Re: Deering Oaks Pond Bottom Replacement – Ravine Improvements  
Request for Plan Revision for Project 2014-096 Level 1 Site Alteration Approval

**PROJECT NAME:** Deering Oaks Pond Bottom & Water Quality Improvements

**DEERING OAKS RAVINE  
SCHEMATIC PLANTING PLAN**  
CITY OF PORTLAND, MAINE

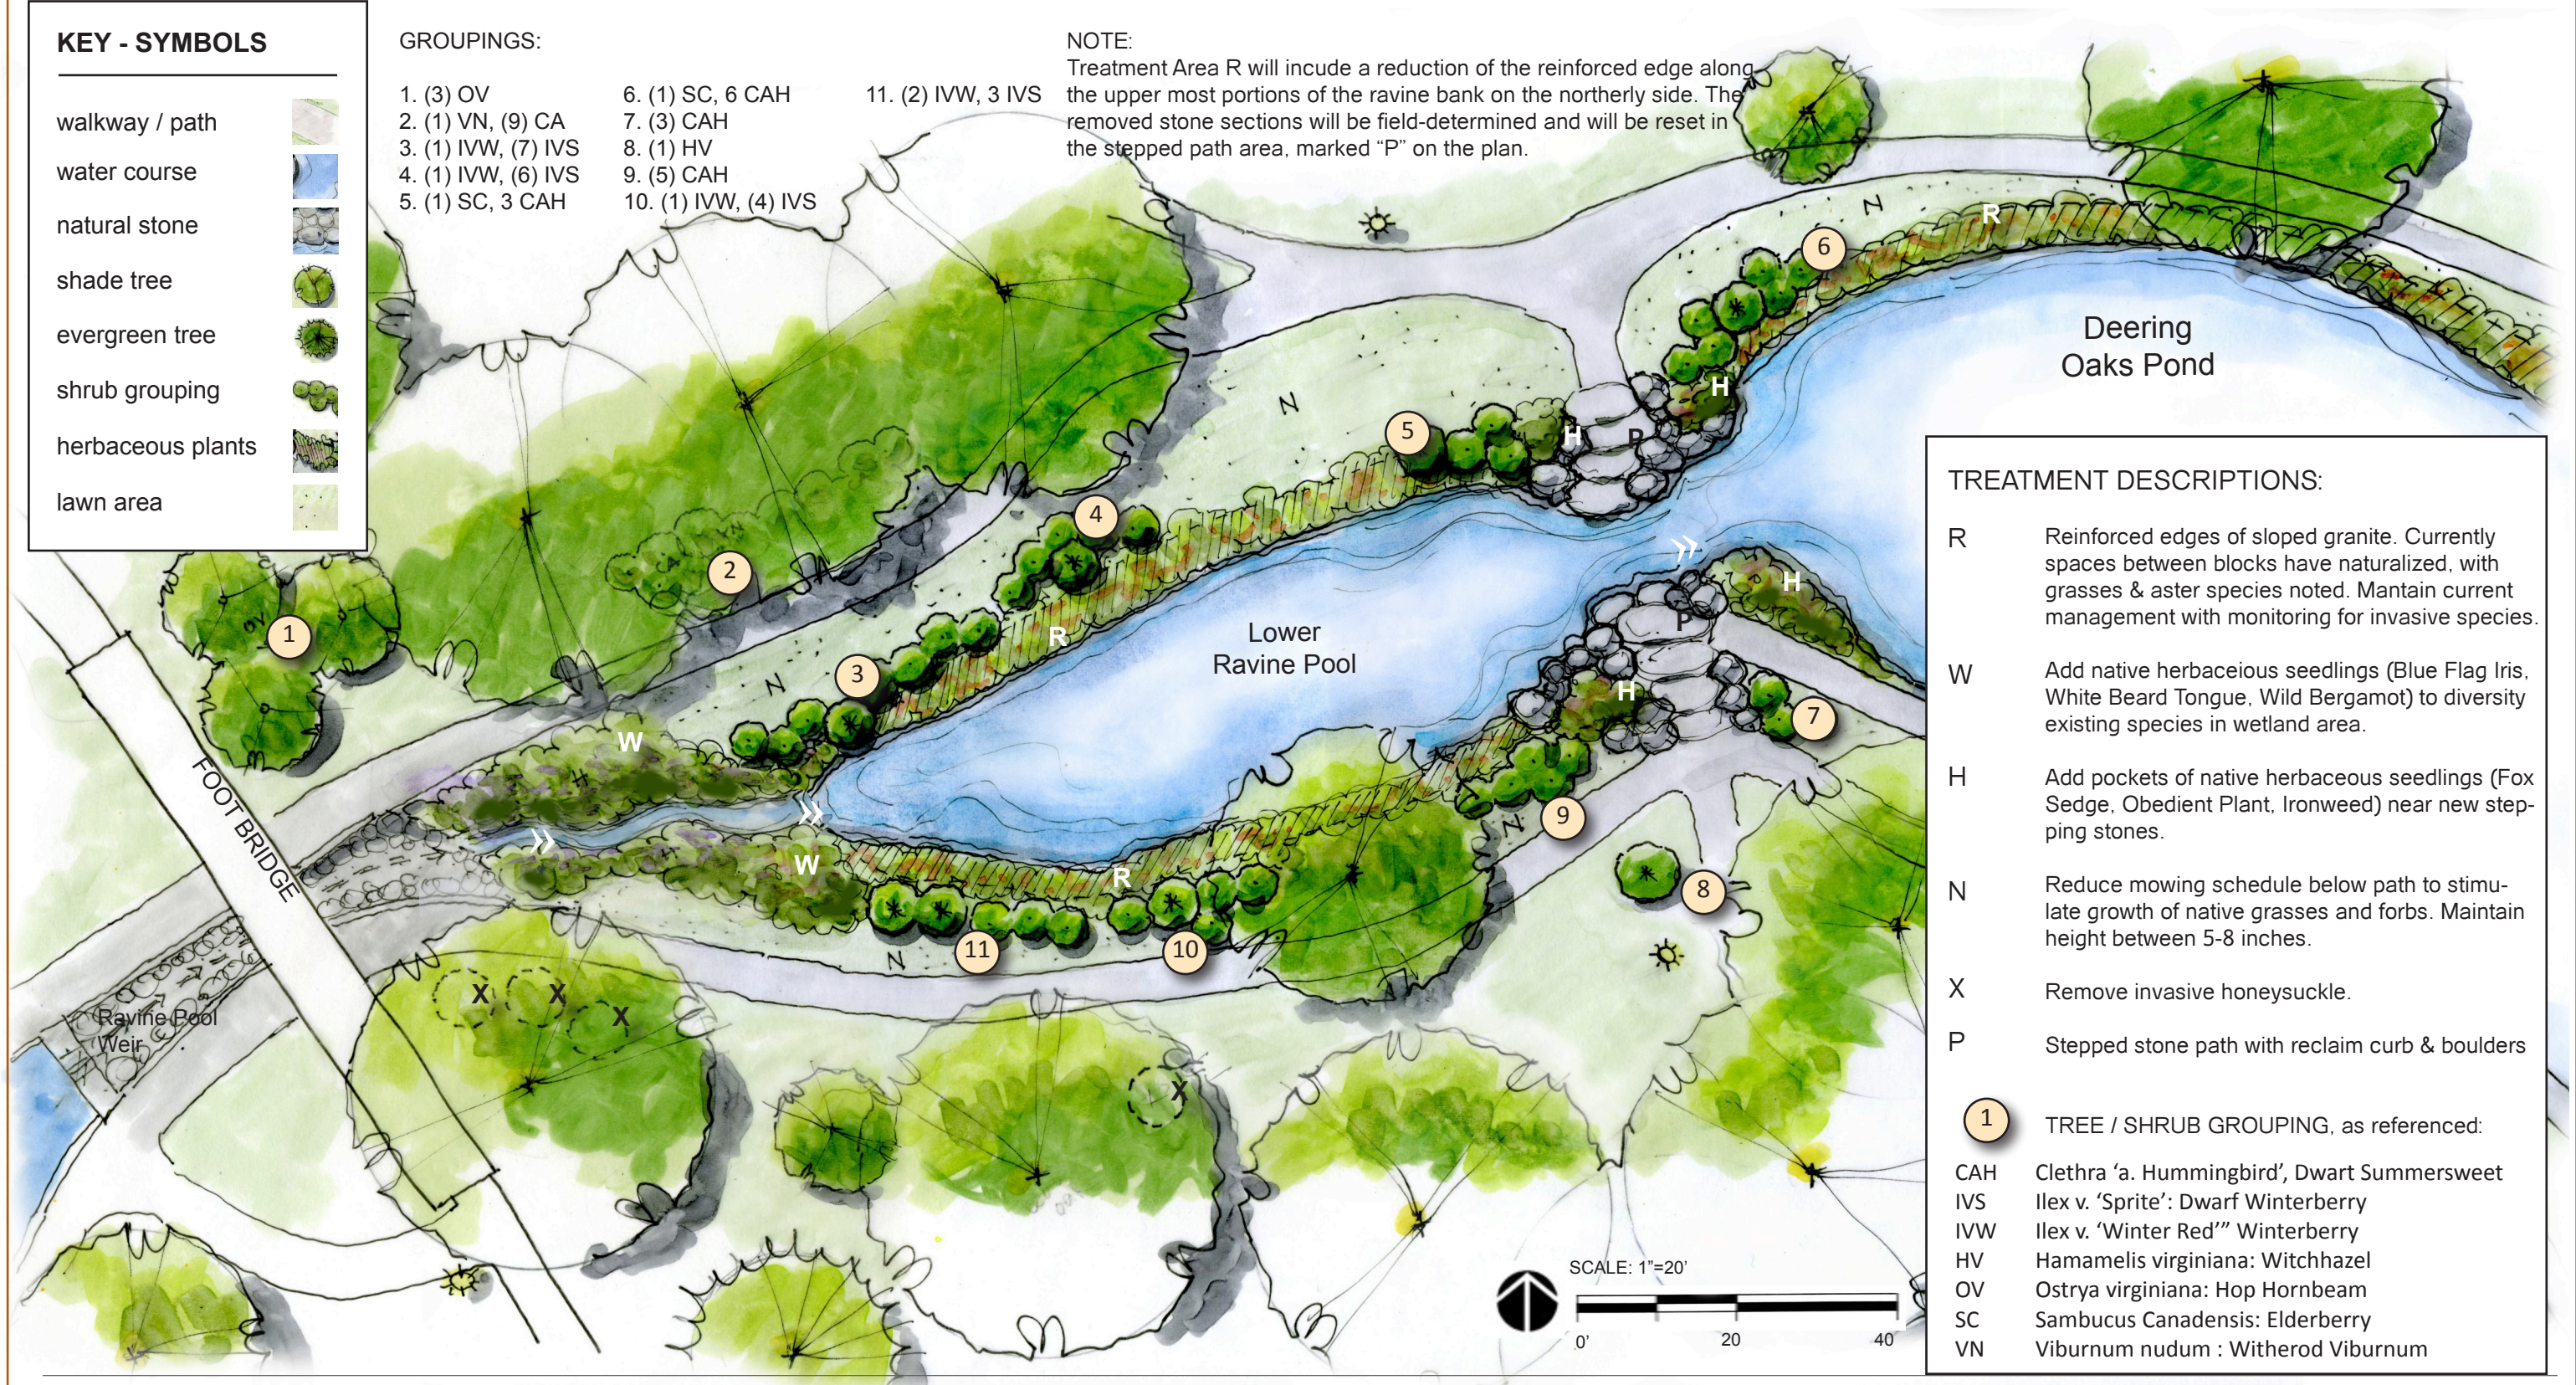
As a result of public comments on the Deering Oaks Pond Bottom Replacement project, the City of Portland's Transportation, Sustainability, & Energy (TSE) Committee requested that the design team pursue improvements to the ravine area of Deering Oaks Pond. The goal was to increase buffer vegetation along the ravine and help stabilize the inslopes of the ravine. In response to the TSE concerns, work proposed in this area will include new plantings, invasive species control and naturalization as shown in detail on the enclosed Schematic Planting Plan.

Treatment Area R will include a reduction of the reinforced edge along the upper most portions of the ravine bank on the northerly side. The removed stone sections will be field-determined and will be reset in the stepped path area, marked "P" on the plan.

- R** Reinforced edges of sloped granite. Currently spaces between blocks have naturalized, with grasses & aster species noted. Maintain current management with monitoring for invasive species.
- W** Add native herbaceous seedlings (Blue Flag Iris, White Beard Tongue, Wild Bergamot) to diversity existing species in wetland area.
- H** Add pockets of native herbaceous seedlings (Fox Sedge, Obedient Plant, Ironweed) near new stepping stones.
- N** Reduce mowing schedule below path to stimulate growth of native grasses and forbs. Maintain height between 5-8 inches.
- X** Remove invasive honeysuckle.
- P** Stepped stone path with reclaim curb & boulders

The proposed plan for lower ravine includes native understory trees, shrubs to stabilize steep banks and herbaceous plants to enhance visual interest and diversity of species in the wetland areas. The reinforced edges of sloped granite will be retained and seeded-in native plants, including grasses and several species of aster, will be nurtured in the spaces between the blocks. The wetland soils just east of the foot bridge will be enhanced with flowering herbaceous plants, such as Blue Flag Iris White Beard Tongue and Wild Bergamot. Colonizing and wettolerant native shrubs, including Winterberry, Summersweet and Elderberry are proposed in groupings along the stabilized bank edge, with Summerweet and Witherod Viburnum proposed in swaths along the northern upland, where the slope is very steep. Hophornbeam trees and Witchhazel plantings supplement the understory in this area.

There are limited improvements proposed beyond plantings. The plan also calls for improving access to the wetland at the former pedestrian bridge location via stepped reclaim curbing bordered by boulders. These stones will be hand selected for rounded edges and will have similar qualities to those in the Ravine Pool Area. At the request of staff, a portion of the reinforced granite edge will be removed and utilized in this area. The stepped feature will allow visitors to explore plantings along the ravine edge while reducing unwanted impacts to planted areas..
